The proposed campsite at Loch Achray – what lessons has the National Park learned?

In September the Loch Lomond and Trossachs National Park Authority submitted a planning application (see here) to itself as planning authority for a new campsite on the south shore of Loch Achray on Forest Drive in the Trossachs. There is widespread agreement that new campsites with basic facilities are needed in the National Park. So far the LLTNPA has been poor at delivering these. It appears to have abandoned the excellent Five Lochs Plan (see here for example) which proposed a number of new campsites in the Trossachs and has also failed to deliver a new campsite this year on the south shore of Loch Earn. This application therefore is welcome. In this post I will look at what the LLTNPA has learned from its experience at Loch Chon and the camping byelaws to date.

Map showing location from planning portal

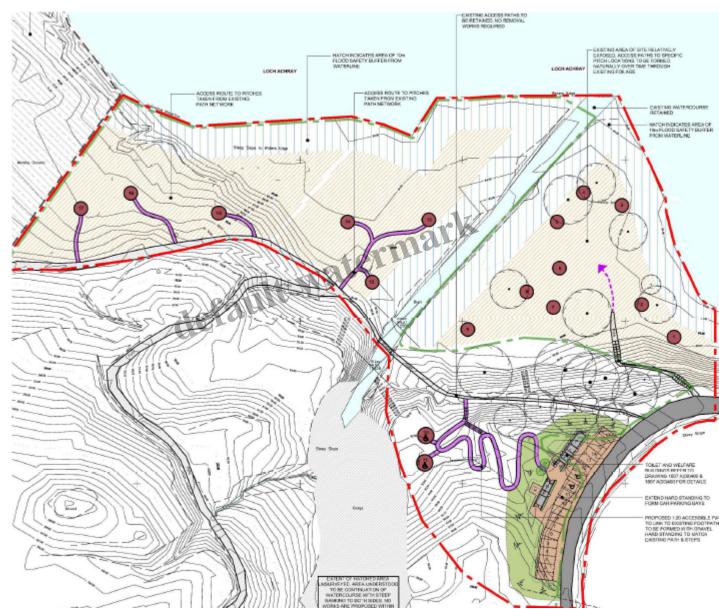
However, you can see from the campsite plan above that the LLTNPA is still wedded to the idea of fixed camping pitches and what is even worse they appear to wish to replace the grassy sward with

bark. That is not a traditional camping pitch, its suburbanisation. The Park would be far better to abandon any idea of fixing camping pitches in this area and allowing people to camp where they choose. This would also enable areas of bare ground to recover. All the Park would need to do to manage this is to put up signs by worn areas asking people to choose a less worn area to pitch their tent (this is how it should be dealing with erosion throughout the Park – there is no need to ban people to protect vegetation).

Three of the places (far left of map above) are in woodland up on the hill well away from the loch. To provide camping places here will require the creation of paths and pitches like at Loch Chon. I suspect the main reason for these pitches is to enable the Park can claim to have provided a certain number of new camping places – its target, which it has failed to meet, was to provide 300 new camping places in the first year of the camping byelaws.

The LLTNPA appears to be repeating he mistakes it made at Loch Chon, which was its failure either to consult campers about where they are likely to camp or to check whether the pitches, as depicted on the map, were campable or not. At Loch Chon many were too sloping or covered in tree roots to provide good camping places. They also failed to provide sufficient space, with many only providing for a tent and no suitable space for sitting or cooking round about. Unfortunately there is still no sign

of the Park consulting campers about what type of camping places are needed but the LLTNPA at least needs to undertake thorough checks before agreeing to the three places here, including that there is sufficient space. I would argue that its money would be better spent on creating camping pitches elsewhere, e.g. at Inveruglas, where the camping permit area is rough and not good for camping at present, similar to these three places, but is much closer to the lochshore and the toilet (if it was opened). If the LLTNPA are going to engineer new camping places, they should consult campers about where best to do this.

On the low-lying area on the west side of the burn (upper centre part of

site plan) the LLTNPA is proposing to provide a further 3 places. This is much closer to the loch than the proposed pitches on the hillside but the edge of the lochshore here is boggy, the ground itself boggy in places and has become overgrown. This perhaps explains why there is little sign of people camping here at present. It could though potentially provide good camping places with some engineering. While not designated as ancient woodland some of the fungi on the trees are fantastic. I would like to see mimimal path creation, with importing of hardstanding materials limited to the boggy areas., to keep it as natural as possible.

The site includes proposals for two camping pitches suitable for people with wheelchairs (bottom of site plan). Its very positive the Park is including facilities for people with disabilities, who are too often excluded from enjoying the countryside, but its unfortunate because of the very steep approach to the loch shore disabilities that people with disabilities will in effect be segregated from other campers (bottom two places in diagram). I hope the places get used. What the LLTNPA should be doing is consulting organisations representing people with disabilities to ensure it has got this right (there are no disability or recreational organisations on the list of those consulted).
